DEVIATION REVIEW AND DECISION FORM

Subdivision or Project Name:
North Bay at Lake Woodmoor

Specific Criteria from Which a Deviation is Sought: Sag and crest vertical curve requirements on Redbridge Point

North Bay at Lake Woodmoor
Deviation Request - Sag and Crest Vertical Curves
El Paso County, Colorado

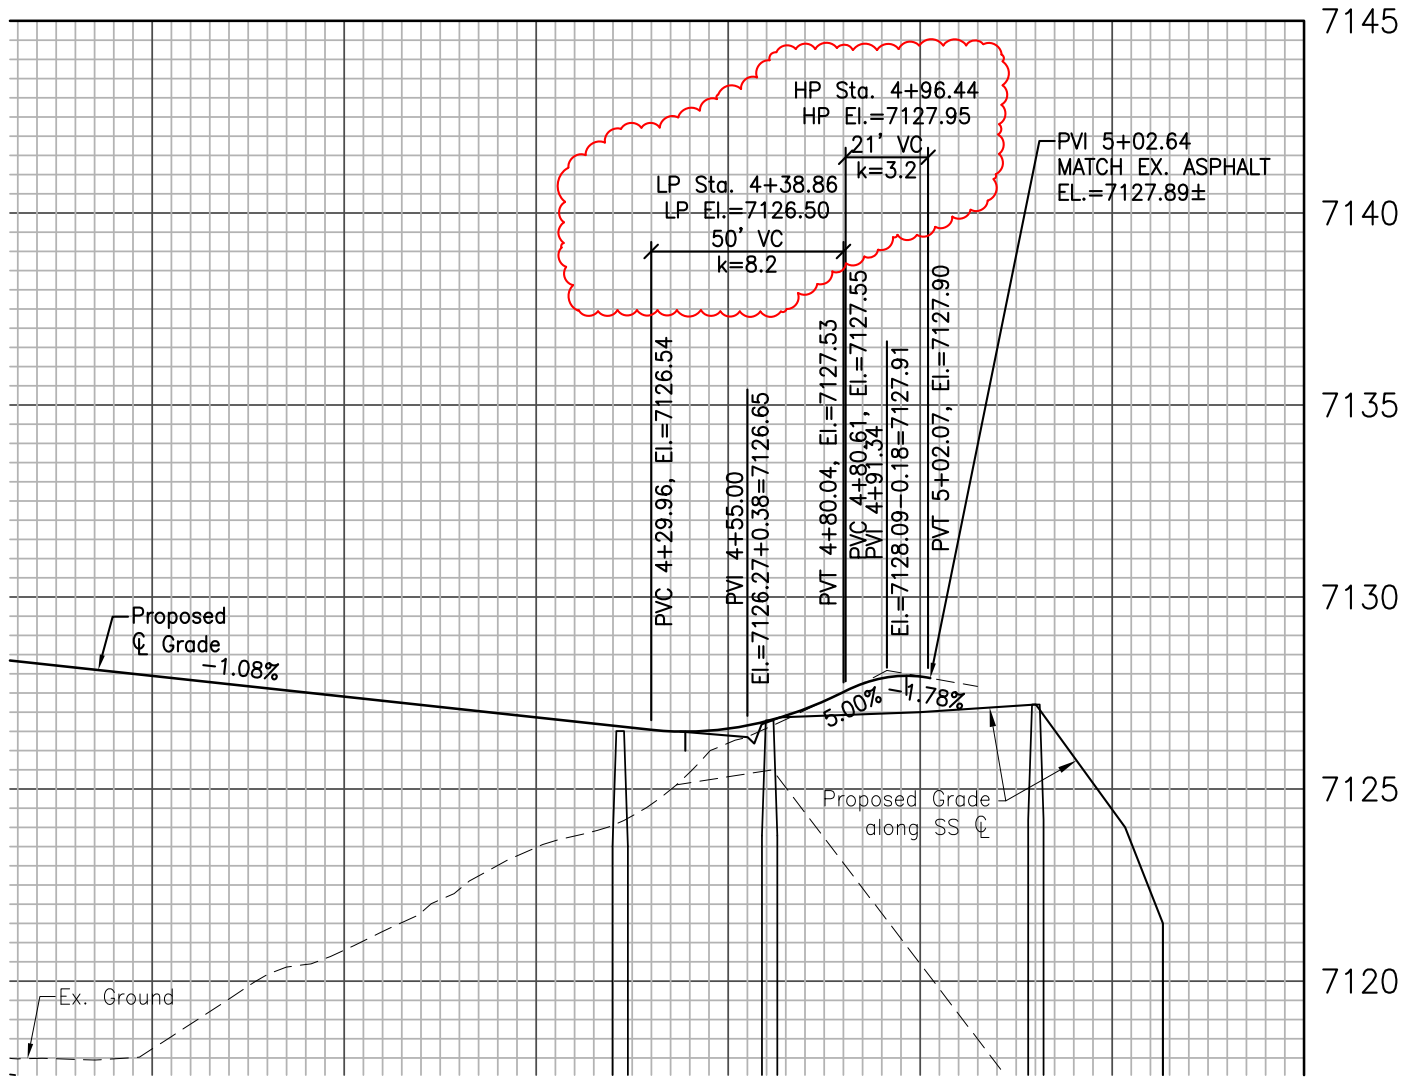
Proposed Nature and Extent of Deviation: _____
Proposed use of sag curve k value of just over 8 and crest curve k value of just over 3 at the southwest end of Redbridge Point where it ties back into the Cove's existing parking and access.

Proposed Nature and Extent of Deviation: The reduction of the sag curve k-value to just over 8 allows for a sight distance of 62.8 feet, where the distance to the intersection is approximately 50 feet.

Reason for the Requested Deviation: Given the layout of the site and Redbridge Point terminating in a t-intersection into the existing Cove's parking and access, a reduced speed is required and the sight distance based upon the curve data is 62.8 feet where the PVI of the curve is approximately 50 feet from the intersection.

Comparison of Proposed Deviation to ECM Standard: _____
Vertical curve will provide 62.8 feet of sight distance where the T-intersection at the end of the private roadway is approximately 50 feet from the PVI of the vertical curve.
